# **APPENDIX A: Facility Reports**

City Hall - Exterior  
 2600 Fresno Street, Fresno

City Hall - North Wing - Second Floor  
 2600 Fresno Street, Fresno

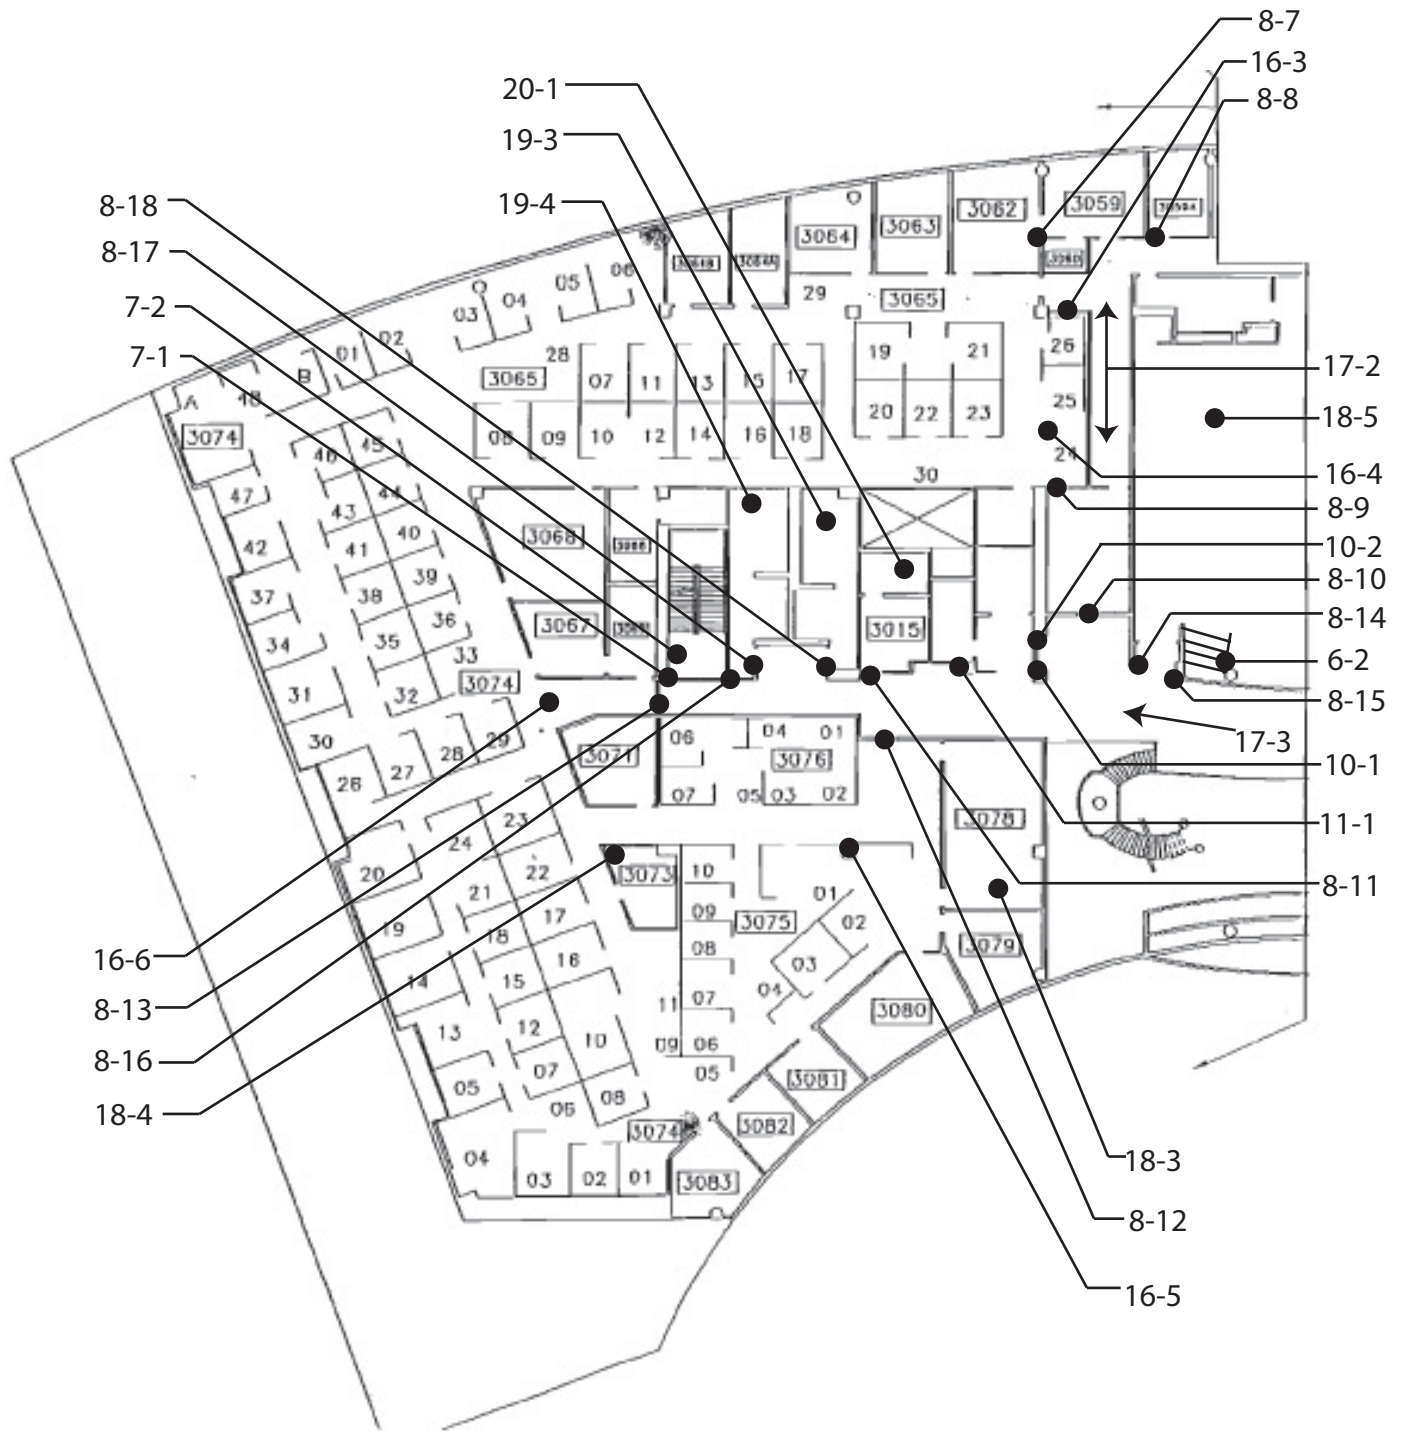
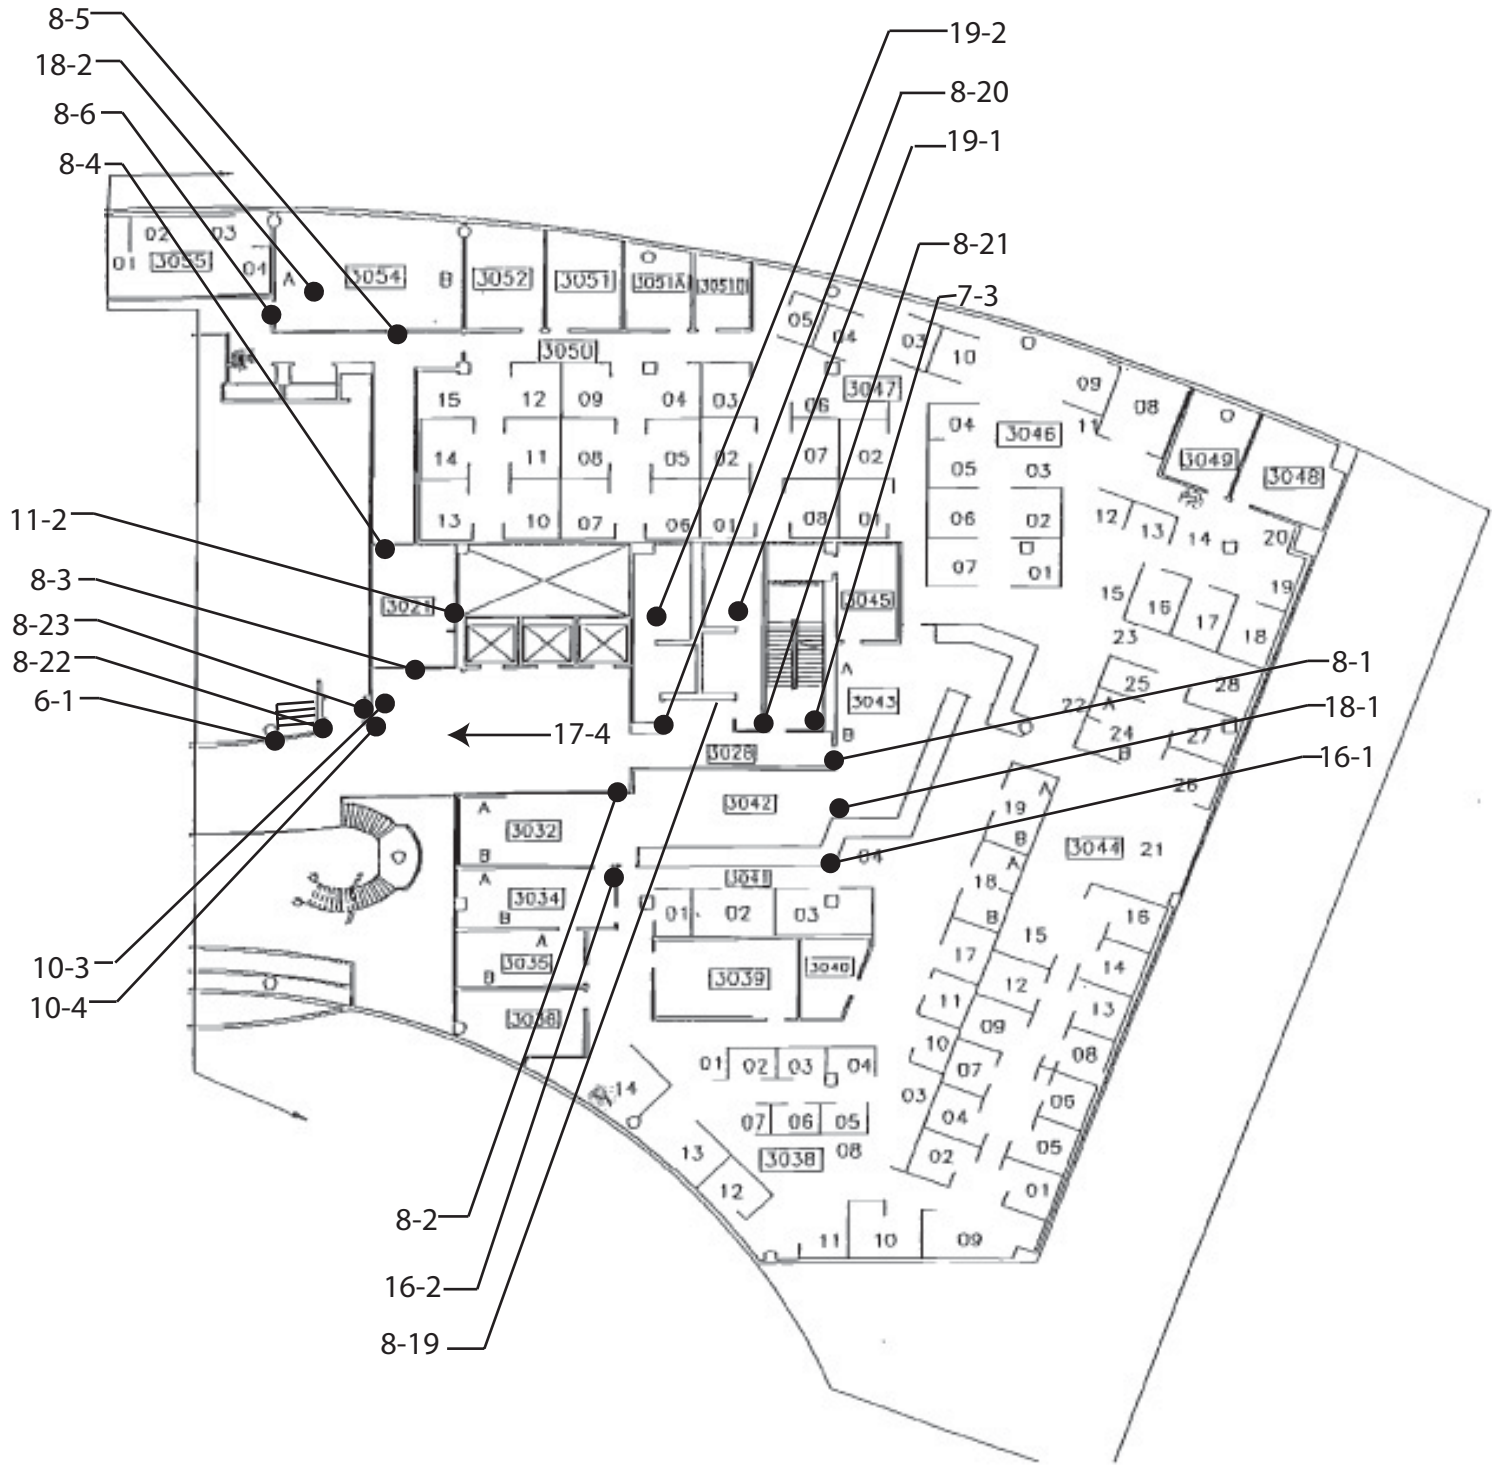
Notes: Fire sprinkler valve protrudes 18" (4" max) and is 75" (not between 27" to 80") above the finished floor.		
State: 1133B.8.6.1		
Federal: 4.4.1		
<b>7 - 4</b>	<b>Hazard</b>	Priority:4
<b>Remove overhanging or protruding objects</b>		\$100
Notes: Standpipe protrudes 25" (4" max) and is 27" (not between 27" to 80") above the finished floor.		
State: 1133B.8.6.1		
Federal: 4.4.1

<b>Floor 2</b>	
<b>8 - 42 Door/Gate</b>	Priority:2
<b>Adjust door closer</b>	\$100
Notes: Operating effort is 10 lbs (5 lbs max). Block open the door.	
State: 1133B.2.5	
Federal: 4.13.11	
<b>8 - 43 Door/Gate</b>	Priority:2
<b>Adjust door closer</b>	\$100
Notes: Operating effort is 7 lbs (5 lbs max).	
State: 1133B.2.5	
Federal: 4.13.11	
<b>8 - 44 Door/Gate</b>	Priority:4
<b>Adjust door closer</b>	\$100
Notes: Operating effort is 10 lbs (15 lbs max for fire door). Add fire signage.	
State: 1133B.2.5	
Federal: 4.13.11	
<b>8 - 45 Door/Gate</b>	Priority:2
<b>Adjust door closer</b>	\$100
Notes: Operating effort is 10 lbs (5 lbs max).	
State: 1133B.2.5	
Federal: 4.13.11	
<b>8 - 46 Door/Gate</b>	Priority:2
<b>Adjust door closer</b>	\$100
Notes: Operating effort is 10 lbs (5 lbs max).	
State: 1133B.2.5	
Federal: 4.13.11	
<b>8 - 47 Door/Gate</b>	Priority:2
<b>Adjust door closer</b>	\$100
Notes: Operating effort is 10 lbs (5 lbs max).

<b>Floor 2</b>	
<b>8 - 65 Door/Gate</b>	Priority:2
<b>Adjust door closer</b>	\$100
Notes: Operating effort is 14 lbs (5 lbs max).	
State: 1133B.2.5	
Federal: 4.13.11	
<b>8 - 66 Door/Gate</b>	Priority:2
<b>Adjust door closer</b>	\$100
Notes: Operating effort is 14 lbs (5 lbs max).	
State: 1133B.2.5	
Federal: 4.13.11	
<b>Replace or modify door threshold</b>	\$300
Notes: Threshold is 1-1/2" (1/2" max) high.	
State: 1133B.2.4.1	
Federal: 4.13.8	
<b>8 - 67 Door/Gate</b>	Priority:2
<b>Adjust door closer</b>	\$100
Notes: Operating effort is 14 lbs (5 lbs max).	
State: 1133B.2.5	
Federal: 4.13.11	
<b>Replace or modify door threshold</b>	\$300
Notes: Threshold is 1-1/2" (1/2" max) high.	
State: 1133B.2.4.1	
Federal: 4.13.8	
<b>8 - 68 Door/Gate</b>	Priority:2
<b>Adjust door closer</b>	\$100
Notes: Operating effort is 14 lbs (5 lbs max).	
State: 1133B.2.5	
Federal: 4.13.11	
<b>Replace or modify door threshold</b>	\$300
Notes: Threshold is 1-1/2" (1/2" max) high.

<b>Floor 2</b>	
<b>8 - 69 Door/Gate</b>	Priority:2
<b>Adjust door closer</b>	\$100
Notes: Operating effort is 14 lbs (5 lbs max).	
State: 1133B.2.5	
Federal: 4.13.11	
<b>Replace or modify door threshold</b>	\$300
Notes: Threshold is 1-1/2" (1/2" max) high.	
State: 1133B.2.4.1	
Federal: 4.13.8	
<b>8 - 70 Door/Gate</b>	Priority:2
<b>Adjust door closer</b>	\$100
Notes: Operating effort is 14 lbs (5 lbs max).	
State: 1133B.2.5	
Federal: 4.13.11	
<b>Replace or modify door threshold</b>	\$300
Notes: Threshold is 1-1/2" (1/2" max) high.	
State: 1133B.2.4.1	
Federal: 4.13.8	
<b>8 - 71 Door/Gate</b>	Priority:2
<b>Adjust door closer</b>	\$100
Notes: Operating effort is 14 lbs (5 lbs max).	
State: 1133B.2.5	
Federal: 4.13.11	
<b>Replace or modify door threshold</b>	\$300
Notes: Threshold is 1-1/2" (1/2" max) high.	
State: 1133B.2.4.1	
Federal: 4.13.8	
<b>8 - 72 Door/Gate</b>	Priority:2
<b>Adjust door closer</b>	\$100
Notes: Operating effort is 14 lbs (5 lbs max).

<b>Floor 2</b>	
<b>8 - 73 Door/Gate</b>	Priority:2
<b>Adjust door closer</b>	\$100
Notes: Operating effort is 14 lbs (5 lbs max).	
State: 1133B.2.5	
Federal: 4.13.11	
<b>Replace or modify door threshold</b>	\$300
Notes: Threshold is 1-1/2" (1/2" max) high.	
State: 1133B.2.4.1	
Federal: 4.13.8	
<b>8 - 74 Door/Gate</b>	Priority:2
<b>Adjust door closer</b>	\$100
Notes: Operating effort is 14 lbs (5 lbs max).	
State: 1133B.2.5	
Federal: 4.13.11	
<b>Replace or modify door threshold</b>	\$300
Notes: Threshold is 1-1/2" (1/2" max) high.	
State: 1133B.2.4.1	
Federal: 4.13.8	
<b>8 - 75 Door/Gate</b>	Priority:2
<b>Adjust door closer</b>	\$100
Notes: Operating effort is 14 lbs (5 lbs max).	
State: 1133B.2.5	
Federal: 4.13.11	
<b>Replace or modify door threshold</b>	\$300
Notes: Threshold is 1-1/2" (1/2" max) high.	
State: 1133B.2.4.1	
Federal: 4.13.8	
<b>8 - 76 Door/Gate</b>	Priority:2
<b>Adjust door closer</b>	\$100
Notes: Operating effort is 14 lbs (5 lbs max).

<b>Floor 2</b>	
<b>8 - 77 Door/Gate</b>	Priority:2
<b>Adjust door closer</b>	\$100
Notes: Operating effort is 14 lbs (5 lbs max).	
State: 1133B.2.5	
Federal: 4.13.11	
<b>Replace or modify door threshold</b>	\$300
Notes: Threshold is 1-1/2" (1/2" max) high.	
State: 1133B.2.4.1	
Federal: 4.13.8	
<b>10 - 1 Drinking Fountain</b>	Priority:4
<b>Provide wing walls or textured floor surface</b>	\$750
Notes: Unit is not positioned in an alcove.	
State: 1115B.4.6 #3	
Federal: 4.15.5	
<b>Replace or reposition drinking fountain</b>	\$3,500
Notes: Depth is 9-1/2" (18" min). "Hi-lo" fountain is not provided.	
State: 1115B.4.6 #1, 1117B.4.6 #2	
Federal: 4.1.6, 4.15.5	
<b>10 - 2 Drinking Fountain</b>	Priority:3
<b>Replace or reposition drinking fountain</b>	\$5,000
Notes: Depth is 9-1/2" (18" min). "Hi-lo" fountain is not provided.	
State: 1115B.4.6 #1, 1117B.4.6 #2	
Federal: 4.1.6, 4.15.5	
<b>10 - 3 Drinking Fountain</b>	Priority:4

<b>Replace or reposition drinking fountain</b>	\$5,000
Notes: Depth is 9-1/2" (18" min).	
State: 1115B.4.6 #1, 1117B.4.6 #2	
Federal: 4.1.6, 4.15.5	
<b>10 - 4 Drinking Fountain</b>	Priority:3
<b>Provide wing walls or textured floor surface</b>	\$750
Notes: Unit is not positioned in an alcove.	
State: 1115B.4.6 #3	
Federal: 4.15.5	
<b>Replace or reposition drinking fountain</b>	\$3,500
Notes: Depth is 9-1/2" (18" min).	
State: 1115B.4.6 #1, 1117B.4.6 #2	
Federal: 4.1.6, 4.15.5

<b>Floor 2</b>	
<b>10 - 5 Drinking Fountain</b>	Priority: 4
<b>Provide wing walls or textured floor surface</b>	\$750
Notes: Unit is not positioned in an alcove.	
State: 1115B.4.6 #3	
Federal: 4.15.5	
<b>Replace or reposition drinking fountain</b>	\$3,500
Notes: Depth is 9-1/2" (18" min).	
State: 1115B.4.6 #1, 1117B.4.6 #2	
Federal: 4.1.6, 4.15.5	
<b>16 - 2 Transaction Counter</b>	Priority: 4
<b>Provide an accessible counter</b>	\$4,000
Notes: Transaction counter is 46" (28" to 34") above the finished floor.	
State: 1122B.5	
Federal: 4.32.4	
<b>16 - 3 Transaction Counter</b>	Priority: 2
<b>Provide an accessible counter</b>	\$4,000
Notes: Transaction counter is 45" (28" to 34") above the finished floor.	
State: 1122B.5	
Federal: 4.32.4	
<b>16 - 4 Transaction Counter</b>	Priority: 4
<b>Provide an accessible counter</b>	\$4,000
Notes: Transaction counter is 45-1/2" (28" to 34") above the finished floor.	
State: 1122B.5

Federal: 4.32.4	
<b>16 - 5 Transaction Counter</b>	Priority: 4
<b>Provide an accessible counter</b>	\$4,000
Notes: Transaction counter is 46" (28" to 34") above the finished floor.	
State: 1122B.5	
Federal: 4.32.4	
<b>17 - 1 Corridor / Aisle</b>	Priority: 4
<b>Reposition controls and outlets</b>	\$250
Notes: Electrical outlets are 11" (15" min) above the finished floor.	
State: 1117B.6.3	
Federal: 4.27.3

<b>Floor 2</b>	
<b>19 - 1 Multiple User Restroom</b>	<b>Priority:2</b>
<b>Provide or replace stall door hardware</b>	<b>\$100</b>
Notes: U-shaped handle is not provided on the back side of stall door.	
State: 1115B.3.1 #4.5	
Federal: 4.13.9	
<b>Modify stall partitions and doors</b>	<b>\$800</b>
Notes: Door width for side-entry stall is 33-1/2" (34" min).	
State: 1115B.3.1 #4.4	
Federal: -	
<b>Reposition toilet flush controls</b>	<b>\$750</b>
Notes: Flush control is not located on the wide side.	
State: 1115B.4.1 #5	
Federal: 4.16.5	
<b>Modify lavatory/counter clearances</b>	<b>\$3,500</b>
Notes: Height of counter is 36" (34" max) above the finished floor. Lower lavatory.	
State: 1115B.4.3 #2	
Federal: 4.19.2	
<b>Replace or reposition dispensers or mirrors</b>	<b>\$100</b>
Notes: Seat cover dispenser is 41" (40" max) above the finished floor.	
State: 1115B.8.3	
Federal: 4.23.7

<b>Floor 2</b>	
<b>19 - 2 Multiple User Restroom</b>	<b>Priority:2</b>
<b>Provide or replace stall door hardware</b>	<b>\$100</b>
Notes: U-shaped handle is not provided on the back side of stall door.	
State: 1115B.3.1 #4.5	
Federal: 4.13.9	
<b>Replace or reposition fixtures</b>	<b>\$1,000</b>
Notes: Space from the other wall to the centerline of the toilet is 18-1/2" (18").	
State: 1115B.7.1.3	
Federal: 4.17.3	
<b>Modify stall partitions and doors</b>	<b>\$500</b>
Notes: Stall width is 55" (60" min).	
State: -	
Federal: 4.17.3	
<b>Modify lavatory/counter clearances</b>	<b>\$3,500</b>
Notes: Height of counter is 36" (34" max) above the finished floor. Lower lavatory.	
State: 1115B.4.3 #2	
Federal: 4.19.2	
<b>Modify stall partitions and doors</b>	<b>\$800</b>
Notes: Door width for side-entry stall is 33-1/2" (34" min).	
State: 1115B.3.1 #4.4	
Federal: -	
<b>Replace or reposition dispensers or mirrors</b>	<b>\$100</b>

<b>Floor 2</b>	
<b>19 - 3 Multiple User Restroom</b>	<b>Priority: 4</b>
<b>Provide or replace stall door hardware</b>	<b>\$100</b>
Notes: U-shaped handle is not provided on the back of stall door.	
State: 1115B.3.1 #4.5	
Federal: 4.13.9	
<b>Reposition toilet flush controls</b>	<b>\$750</b>
Notes: Flush control is not located on the wide side.	
State: 1115B.4.1 #5	
Federal: 4.16.5	
<b>Modify lavatory/counter clearances</b>	<b>\$3,500</b>
Notes: Height of counter is 36" (34" max) above the finished floor. Lower lavatory.	
State: 1115B.4.3 #2	
Federal: 4.19.2	
<b>Modify stall partitions and doors</b>	<b>\$800</b>
Notes: Door width for side-entry stall is 33-1/2" (34" min).	
State: 1115B.3.1 #4.4	
Federal: -	
<b>Replace or reposition dispensers or mirrors</b>	<b>\$100</b>
Notes: Seat cover dispenser is 41" (40" max) above the finished floor.	
State: 1115B.8.3	
Federal: 4.23.7

<b>Floor 2</b>	
<b>19 - 4 Multiple User Restroom</b>	Priority: 4
<b>Modify lavatory/counter clearances</b>	\$3,500
Notes: Height of counter is 36" (34" max) above the finished floor. Lower lavatory.	
State: 1115B.4.3 #2	
Federal: 4.19.2	
<b>Provide or replace stall door hardware</b>	\$100
Notes: U-shaped handle is not provided on the back of stall door.	
State: 1115B.3.1 #4.5	
Federal: 4.13.9	
<b>Modify stall partitions and doors</b>	\$800
Notes: Door width for side-entry stall is 33-1/2" (34" min).	
State: 1115B.3.1 #4.4	
Federal: -	
<b>Replace or reposition dispensers or mirrors</b>	\$100
Notes: Seat cover dispenser is 41" (40" max) above the finished floor.	
State: 1115B.8.3	
Federal: 4.23.7	
<b>20 - 1 Single User Restroom</b>	Priority: 4
<b>Modify lavatory/counter clearances</b>	\$3,500
Notes: Height of counter is 36" (34" max) above the finished floor. Lower lavatory.	
State: 1115B.4.3 #2	
Federal: 4.19.2

<b>Floor 2</b>	
<b>25 - 1 Kitchen</b>	Priority: 4
<b>Provide an accessible counter</b>	\$4,000
Notes: Height of counter is 36" (34" max) above the finished floor. Base cabinet directly under the sink does not provide clearance for wheelchair.	
State: 1115B.4.7 #1	
Federal: 1115B.4.7 #1	
<b>Modify lavatory/counter clearances</b>	\$3,500
Notes: Height of counter is 36" (34" max) above the finished floor.	
State: 1115B.4.7 #1	
Federal: 4.24.2	
<b>25 - 2 Kitchen</b>	Priority: 4
<b>Provide an accessible counter</b>	\$4,000
Notes: Height of counter is 36" (34" max) above the finished floor. Base cabinet directly under the sink does not provide clearance for wheelchair.	
State: 1115B.4.7 #1	
Federal: 1115B.4.7 #1	
<b>Modify lavatory/counter clearances</b>	\$3,500
Notes: Height of counter is 36" (34" max) above the finished floor.	
State: 1115B.4.7 #1	
Federal: 4.24.2	
<b>25 - 3 Kitchen</b>	Priority: 4
<b>Provide an accessible counter</b>	\$4,000

<b>Floor 2</b>	
<b>27 - 1 Auditorium</b>	Priority:2
<b>Provide accessible seating</b>	\$1,500
Notes: Removable armrests are not provided on the aisle sides. Provide 1% (at least one) of all fixed seats on the aisle to have removable armrests. Indicate these seats with an ISA.	
State: 1104B.3.4 #1	
Federal: -	
<b>Install sign</b>	\$250
Notes: Accessible aisle seats are not identified by a marker or sign.	
State: 1104B.3.4 #1	
Federal: -	
<b>Install sign</b>	\$250
Notes: Signage that indicates the auditorium provides assistive listening devices is not provided.	
State: 1104B.2 #4	
Federal: 4.30.7 #4
